RE: Comments on 'Response to Kondolf (2017) "Review of the Sonoita Creek Mitigation Project Proposal for the Proposed Rosemont Copper Mine"' by Water & Earth Technologies, January 2018

Comments on 'Response to Kondolf (2017) "Review of the Sonoita Creek Mitigation Project Proposal for the Proposed Rosemont Copper Mine"' by Water & Earth Technologies, January 2018

G Mathias Kondolf, PhD

Figure 1. Design for artificial channel proposed to replace Sonoita Creek, showing sinuosity of over 1.36 from confluence of Tributary E1 to Tributary E3 (detail from WET Drawing 11, excerpted from my 2017 report).

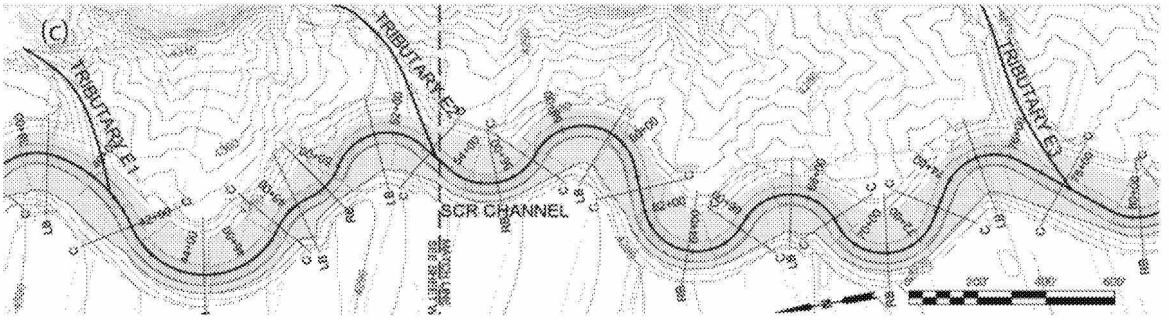
Sinuosity and Misrepresentations of My 2017 Comments
In my 2017 comments, I noted the high sinuosity of the proposed artificial channel (Figure 1), and I pointed out that many stream reconstruction projects elsewhere had failed by the channel cutting across meander bends and creating a straighter channel than what had been constructed. This is a serious concern, especially because the generous credits the proponents claim for the artificial channel are based on the unnaturally large meander bends proposed and the consequently increased length of the channel. I noted that the sinuosity of the Sonoita Creek channel in Rail X Ranch and from the 'reference reach' downstream to the point where Sonoita Creek begins to follow Hwy 82, and the sinuosity of Walnut Gulch on the 'reference reach' identified by WET, were all approximately 1.07, much lower than the sinuosity of the ideally meandering, artificial channel proposed by WET.

WET (p.8) misleadingly claims that I presented "...1.07 as the sinuosity value that should apply to the proposed channel..." This is false. At no point in my report did I "present" any sinuosity value "that should apply" to an artificial channel in the Sonoita Creek valley. As no scientifically valid case has been made for filling in the existing Sonoita Creek and replacing it with an artificial channel, I do not propose any sinuosity for a channel that should not be built.

In attempting to argue against my critique of the highly sinuous artificial channel proposed, WET (p.11) states that the proposed artificial channel is designed to be flanked by low, easily inundated benches, so that "significant storm events with a flow depth great than 2-feet deep will have a straighter flow path..." Thus, the flow path at higher flows will be straighter, cutting across meander bends. WET introduces a new variable, "dominant sinuosity" of the channel, which WET (p.11) defines as the "sinuosity of flood inundation during the 5-year event," and which will be much lower than the sinuosity of the active channel visible on the plans presented by WET (2017). Introducing this new variable serves to confuse the discussion of sinuosities. It is important to recognize that "dominant sinuosity" is not an accepted term in fluvial geomorphology. Rather, it is a new creation, part of the onslaught of words presented by WET (2018) in its response to my 2017 report. While these words (and their accompanying tables and figures) can initially give an impression of substance, in the end they are mostly irrelevant and fail to support the WET arguments.

More importantly, however, the acknowledgement by WET that high flows will cut across the meander bends supports my point that flood flows are likely to cut across the exaggerated meanders and create a straighter path, eroding the unprotected sediments in the channel banks. The result is likely to be that meander bends will be abandoned and a straighter channel will result, offering far less mitigation acreage than promised for the highly meandering artificial channel proposed for construction.

The proposed design of the artificial channel encourages flood flows to cut across the meander bends, which will almost certainly result in meander cutoffs, which will not be repaired. The straighter channel that results will not have the large mitigation acreage that the proponents seek in the highly sinuous artificial channel they propose.
